J2 TECHNICAL ARTICLE

Number 104

BOTTOM FIREWALL (BULK HEAD) RUBBER FUME SEAL

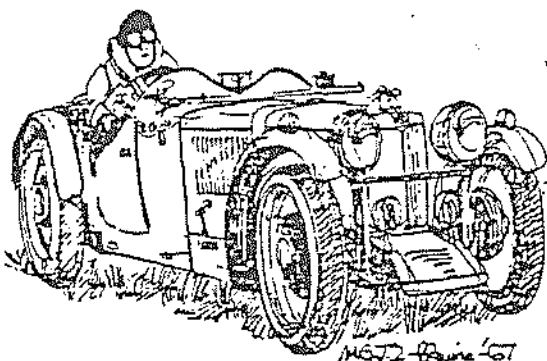
Question: The bottom firewall rubber fume seal looks like the sketch below. How does it fit over the bulk head? Does it fit only over the front "skin" or does it fit over the whole thing?
